UNITED STATES PATENT AND TRADEMARK OFFICE

APPLICATION NO.	FILING DATE	FIRST NAMED INVENTOR	ATTORNEY DOCKET NO.	CONFIRMATION NO.
10/777,756	02/13/2004	Ryu Ogiwara	248861US2S	5332

Office Action Summary

DETAILED OFFICE ACTION

FIG. 5

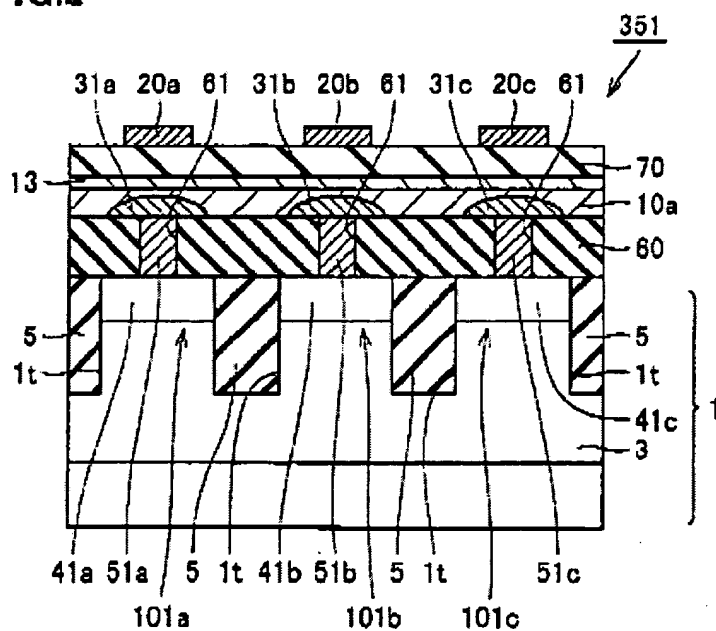
Kuge discloses (in the title, fig 2,fig 5, fig 11,column 1 lines 16-25) a phase-change memory device comprising: memory cells (fig 1 reference 31a) including phase-change layers formed on a semiconductor substrate, the phase-change layer showing an amorphous-crystalline phase change; a memory cell array which has the memory cells arranged in a matrix, the phase change layer including first regions (fig 2 layer 3) which contact the semiconductor substrate in units of memory cells and a second region (fig 2 layer 41a) which connects the first regions arranged in a same column; a first electrode layer (fig 2 layer 10a) formed on the second

FIG. 11

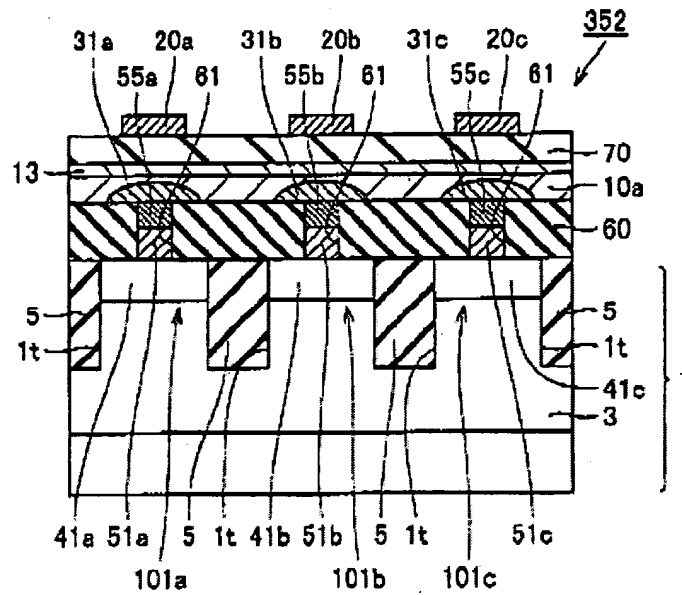
Kuge (fig 11) discloses a phase change memory device wherein each memory cell includes a bipolar transistor formed in the semiconductor substrate, a collector or an emitter of the bipolar transistor being connected to a corresponding one of the first regions, a base of the bipolar transistor being connected to the word line (fig 11 line 41a).

FIG. 1

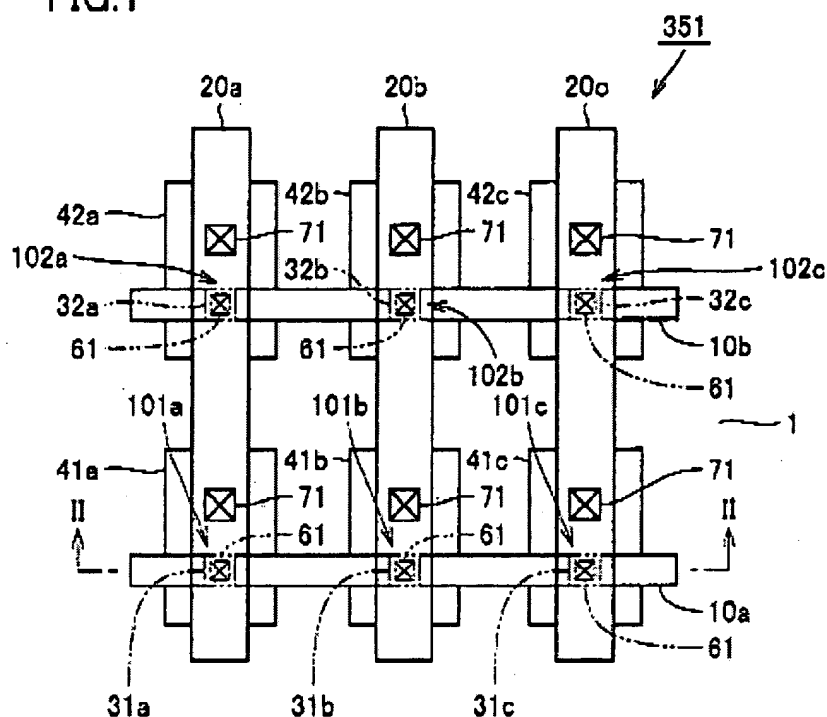
Kuge (fig 1,fig 11) discloses a phase change memory device comprising a contact plug, which connects the first electrode layer and the bit line (fig 1 contact hole 61 bit line 10a).

Kuge (fig 1,column 1 lines 16-25,column 5 lines 5-7) discloses a phase change memory device comprising the second region of each phase-change layer is in a crystalline state, and at least part of each first region of each phase-change layer assumes one of the crystalline state and an amorphous state in accordance with write data.

Noted that even though Kuge does not mentioned that layer 10a is polycrystalline; layer 10a is inherently in polycrystalline state since it is a chalcogenide contact layer while storage layer 31a can change phase from polycrystalline to amorphous.

FIG. 2

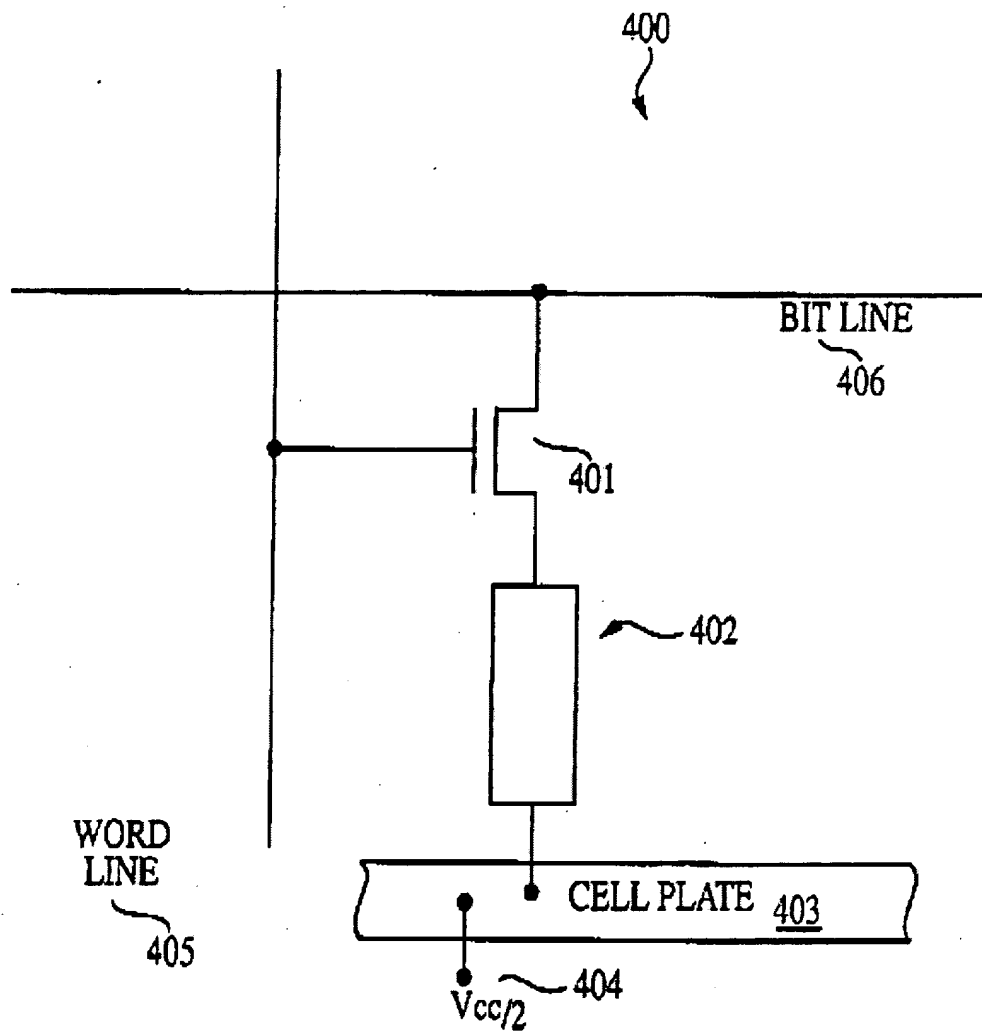
Kuge discloses all the invention except for using a MOSFET switching element. Hush, however, (fig 2) discloses the use of a MOSFET switching element for a phase change memory device.

a person skilled in the art at the time the invention was made would have been motivated to use an alternative of Bipolar Junction Transistor Switch by a MOSFET switch as taught by Hush to improve the device by Kuge since MOSFET are known in the art as consume less power than BJT.
